Campaign No. 2021060010, July 2021

SUBJECT: **Model C-Class Convertible and E-Class Convertible (205 and 238 platform)
Model year 2021**

Check Guide Bushing on Rear Head Restraints

Figure 1

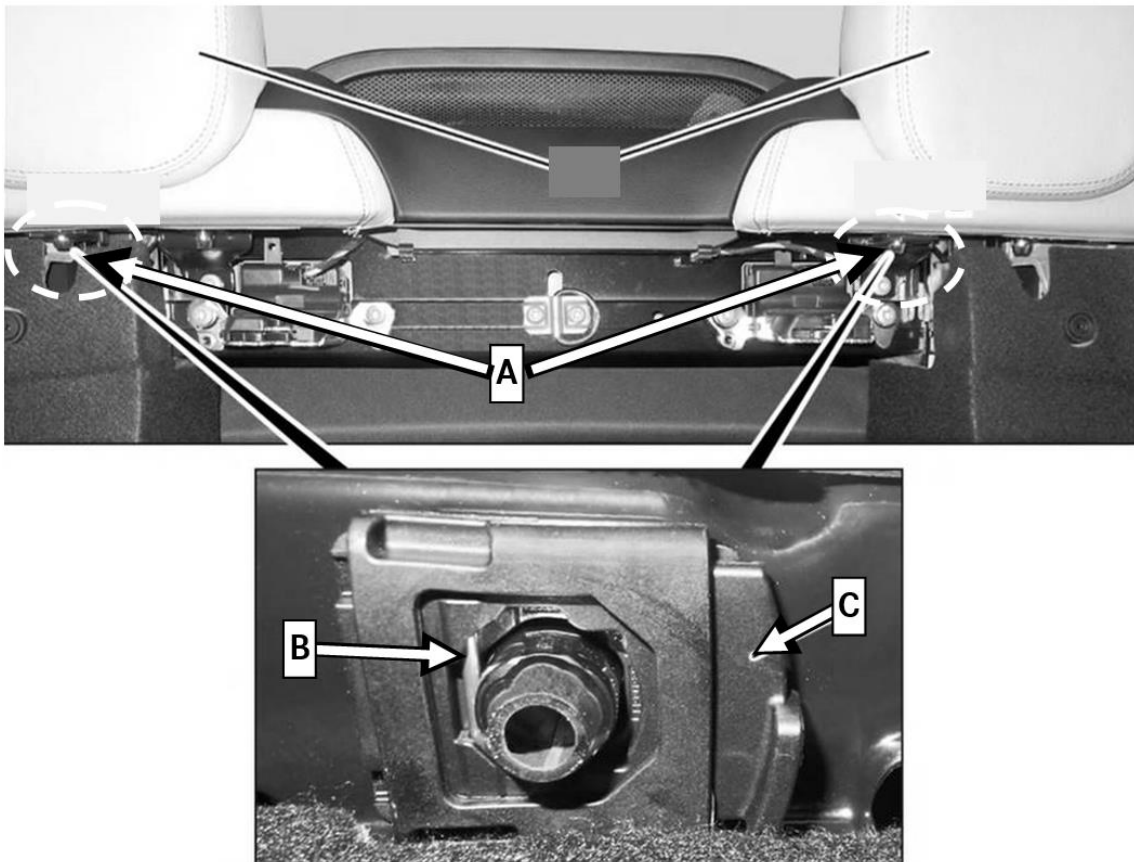
i A head restraint guide sleeve with a locking clip and release lever must be installed in the direction of travel on the **right side of each head restraint (A, Figure 1)**.

i In each case, the **locking clip (B, Figure 1)** must **point toward the right side of the vehicle**.

i In each case, the **release lever (C, Figure 1)** must **point toward the left side of the vehicle**.

i Guide sleeves without a lock must be installed in the direction of travel on the left side of the head restraints.

- a. Head restraint guide sleeve or sleeves twisted or installed on the wrong side: Carry out **work procedure**.
- b. Head restraint guide sleeves installed **correctly: End measure**.

1. Replace incorrectly installed head restraint guide sleeves (AR91.16-P-1776LWR)
